Village of Arlington Heights  
Plat and Subdivision Committee  
Community Room, 3rd Floor  
Arlington Heights Village Hall  
33 S. Arlington Heights Road  
Arlington Heights, IL 60005  
January 14, 2015  
6:30 PM

**Item:** Northwest Crossings - 1501 & 1421 W. Shure Dr.- T1470

## **STAFF DEVELOPMENT COMMITTEE REPORT**

**Item:** Wireless Antenna Tower - 1000 S. Arlington Heights Rd. - T1487

SITE PLAN OPTION A

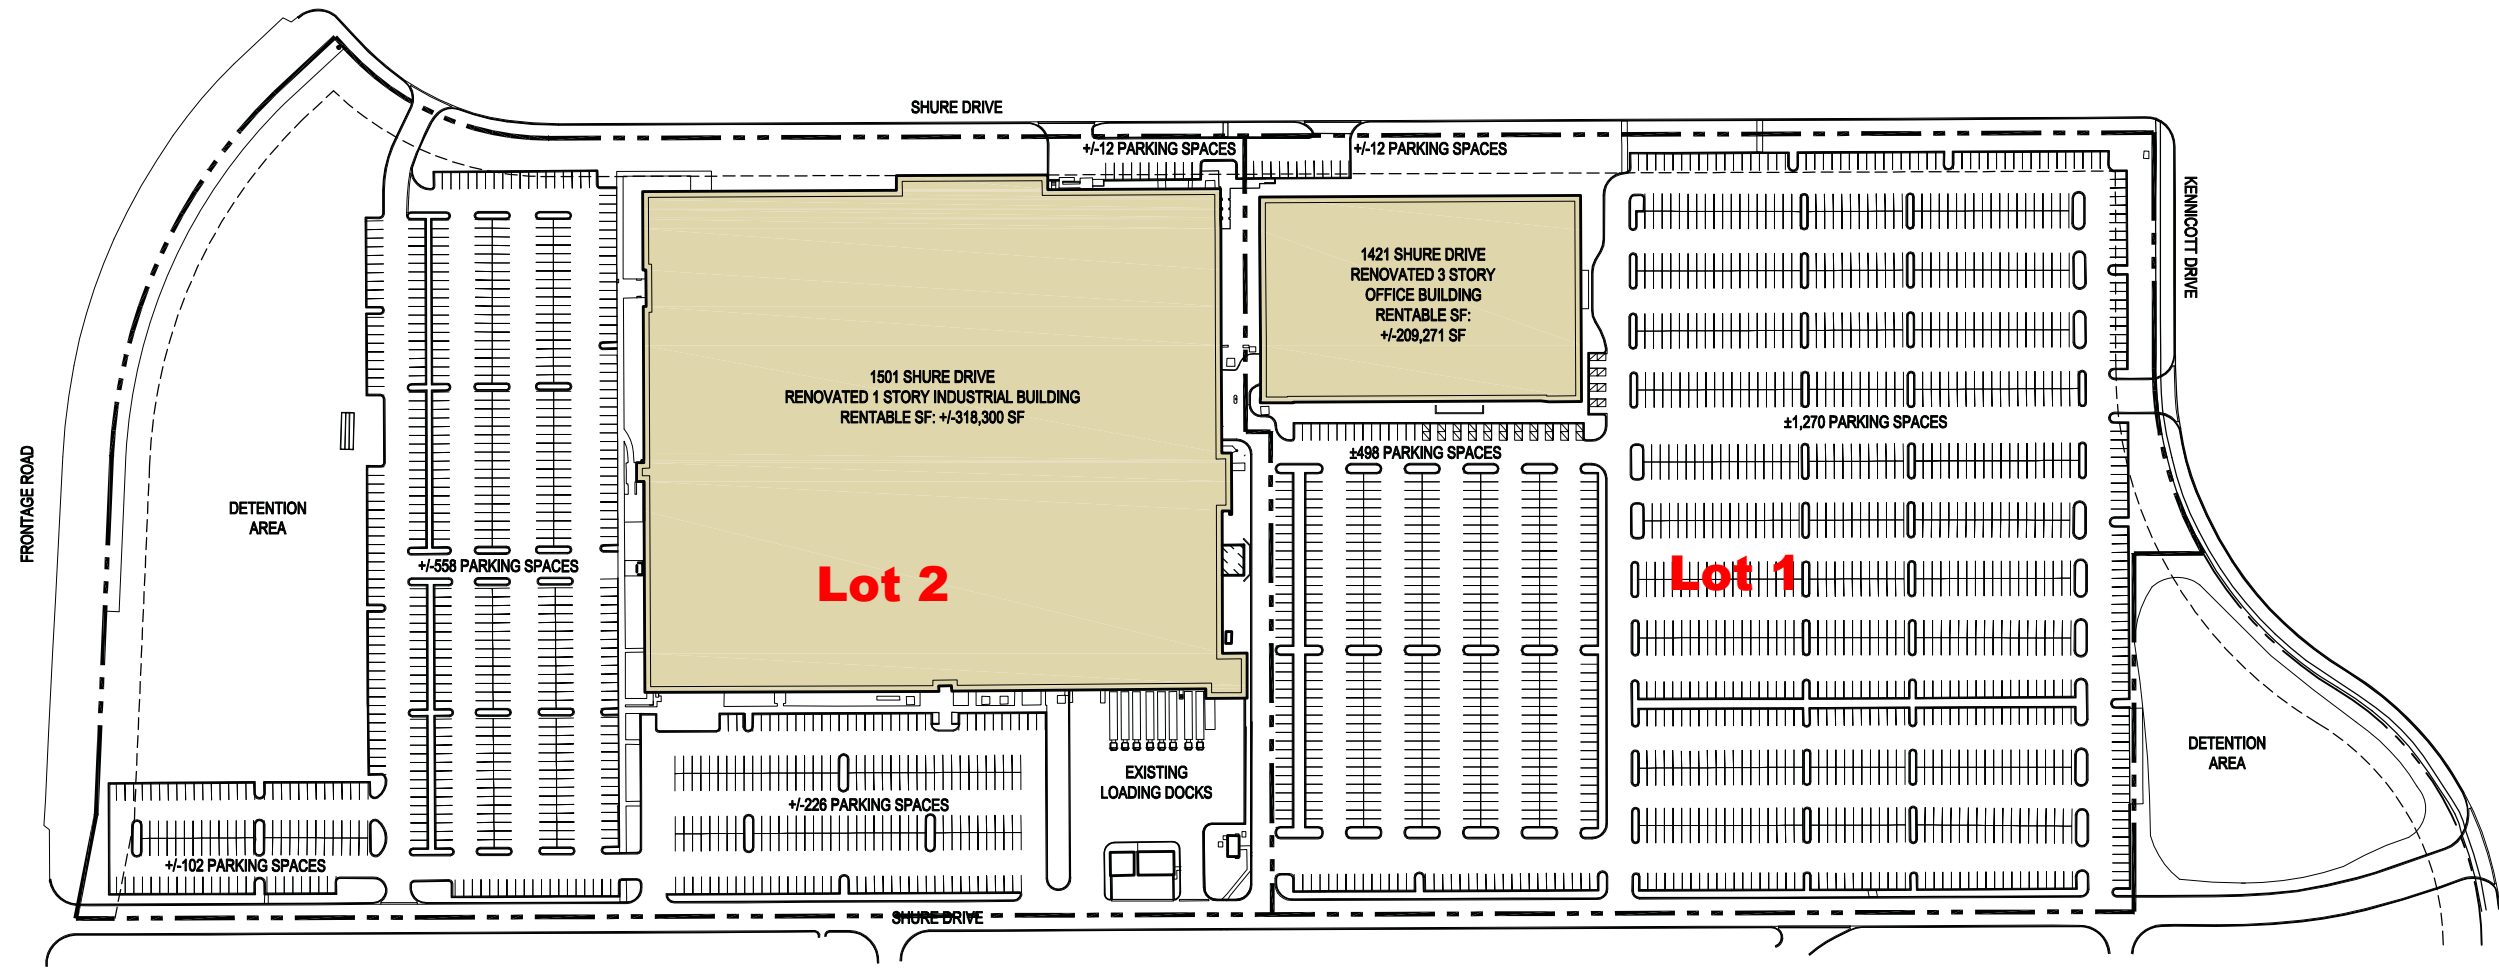
- A variation from Chapter 28, Section 11.4 Schedule of Parking requirements, from the required 1062 parking spaces to allow 898 parking spaces for Lot 2 (1501 W. Shure Dr.);
- A variation from Chapter 28, Section 5.1-17.7 from the required minimum yards, to allow a reduced rear yard for Lots 1 and 2 (1421 W. Shure Drive and 1501 W. Shure Dr.) of 15 feet and 0 feet instead of the required 30 feet.

As indicated in the table above, a variation from the required number of 1063 parking spaces to allow 898 spaces, a variation of 164 spaces will be required for Lot 2 (Site Plan A). Shared parking agreements should be explored between the two lots, as a surplus of spaces are available for Lot 1.

SITE PLAN OPTION B

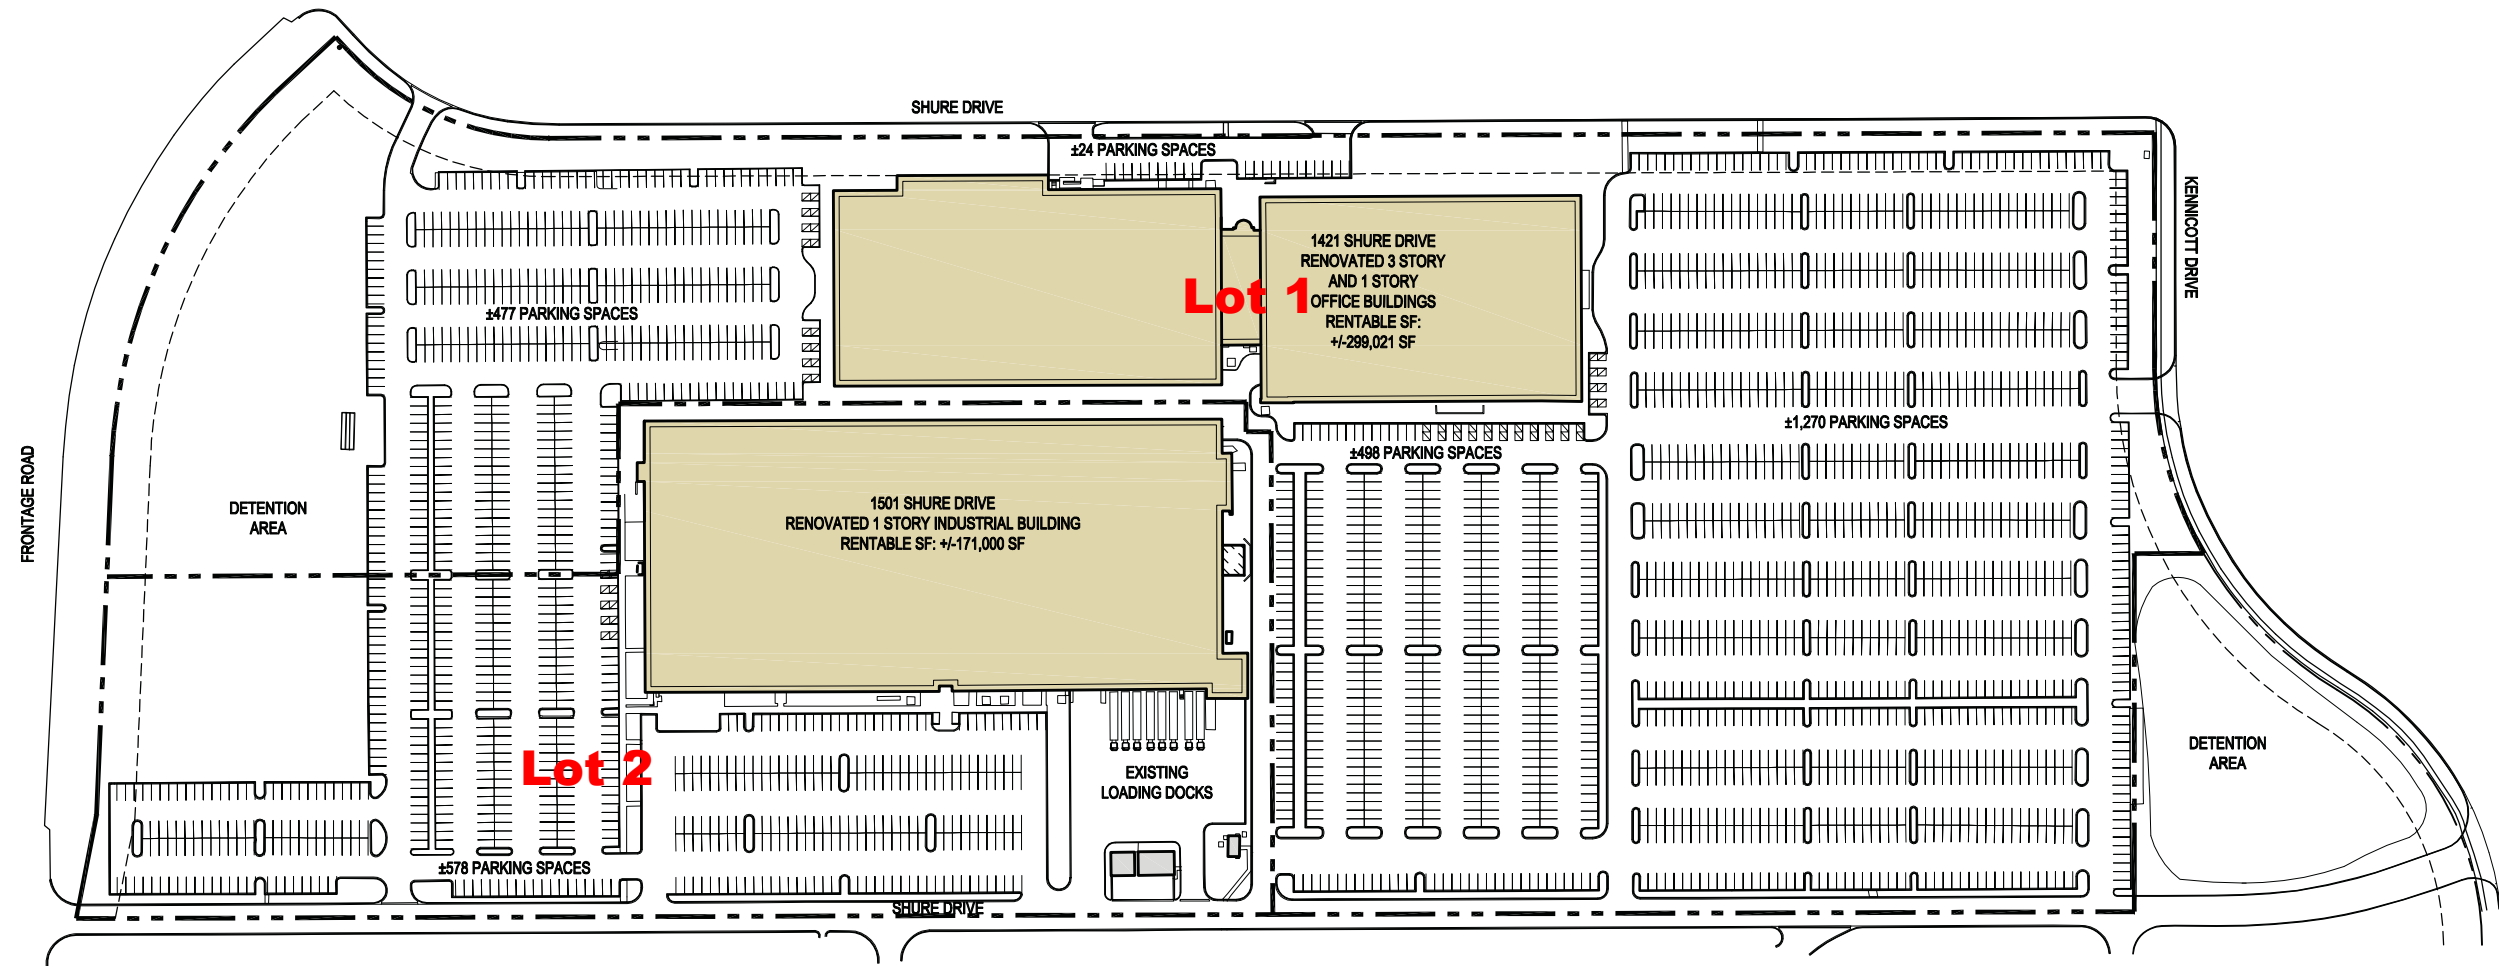
- Variation from Section 5.1-17.7, from the required minimum yards to allow a reduced side yard for Lot 1 (1421 W. Shure Drive) of 20 feet instead of the required 45 feet (10 percent of lot width, not to exceed 50 feet);
- Variation from Section 5.1-17.7 from the required minimum yards to allow reduced side yards and rear yard for Lot 2 (1501 W. Shure Drive) of 20 feet and 0 feet instead of the required 35.5 feet (10 percent of lot width, not to exceed 50 feet) and 30 feet respectively.

SITE PLAN OPTION C

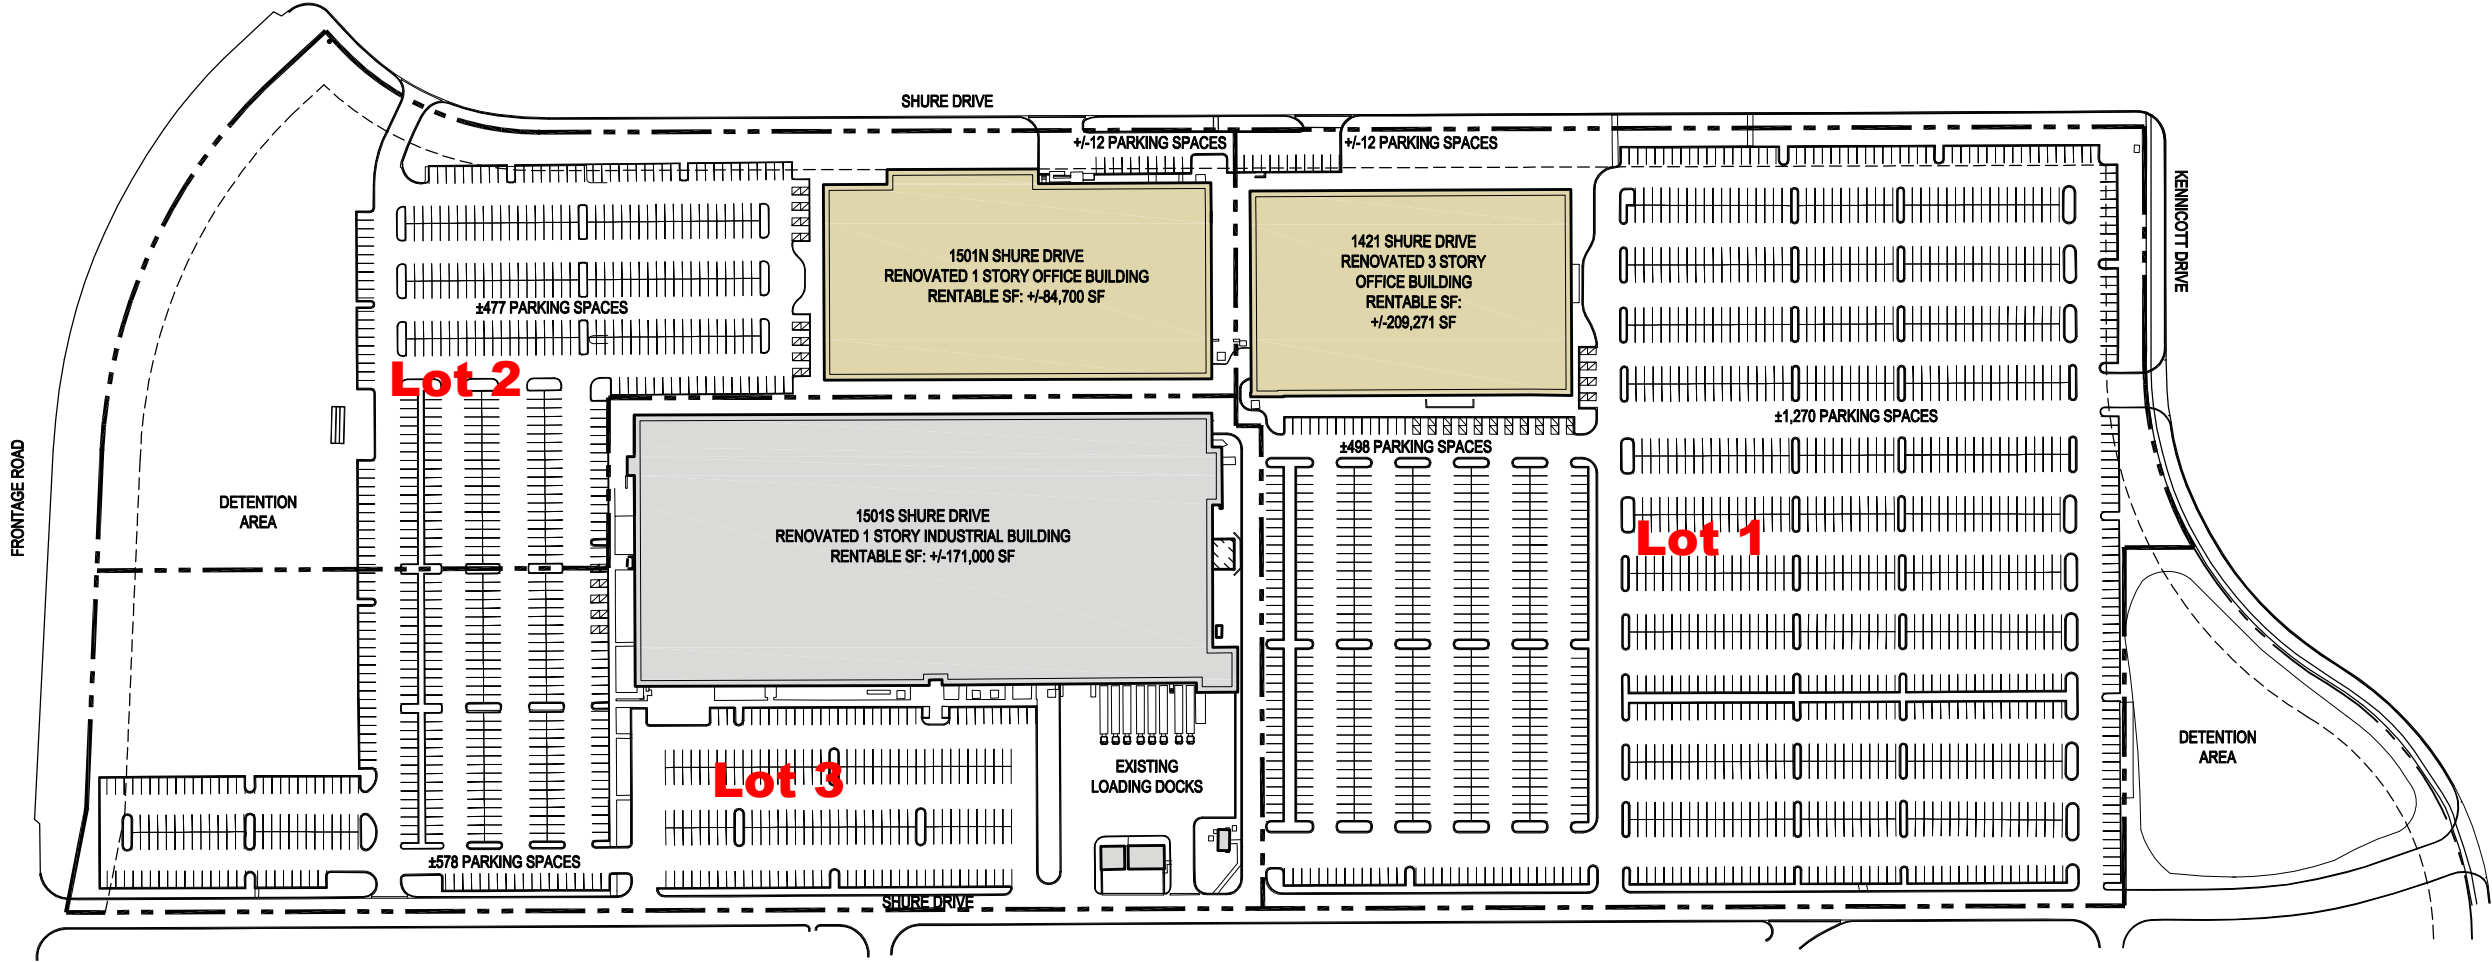
- Variation from Section 5.1-17.7, from the required minimum yards to allow a reduced rear yard for Lot 1 (1421 W. Shure Drive) of 15 feet instead of the required 30 feet;
- Variation from Section 5.1-17.7, from the required minimum yards to allow reduced side yards and rear yard for Lot 2 (1501 W. Shure Drive - North) of 20 feet and 25 feet instead of the required 50 feet (10 percent of lot width, not to exceed 50 feet) and 30 feet respectively;
- Variation from Section 5.1-17.7 from the required minimum yards to allow a reduced side yard and rear yard for Lot 3 (1501 W. Shure Drive - South) of 20 feet and 0 feet instead of the required 35.5 feet (10 percent of lot width, not to exceed 50 feet) and 30 feet respectively.
